X 91.117-26

## MODELS 42/242

## AIR CONDUCTOR AND STARTER HOUSING

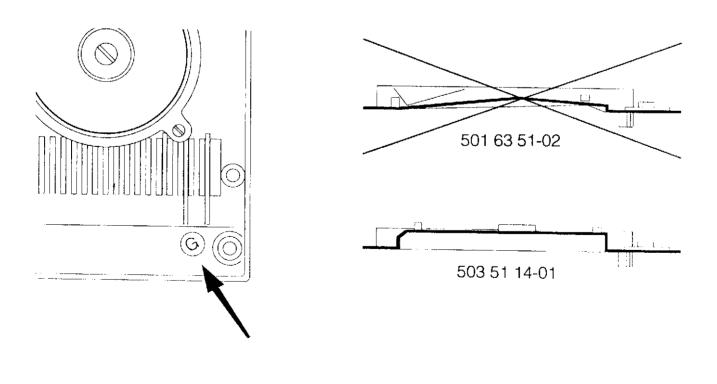
The air conductor is changed in order to receive a better cooling of the cylinder. The starter housing is also adjusted to the new air conductor from production code G.

The new air conductor ref. no. 503 51 14-01 does not fit older starter housings with production code to  ${\rm F.}$

New ref. no.	Description	Excluded ref. no.	Remark
503 51 14-01	Air conductor	501 66 15-02	*

Introduced in our production from serial number: 42 1050409 242 1050444
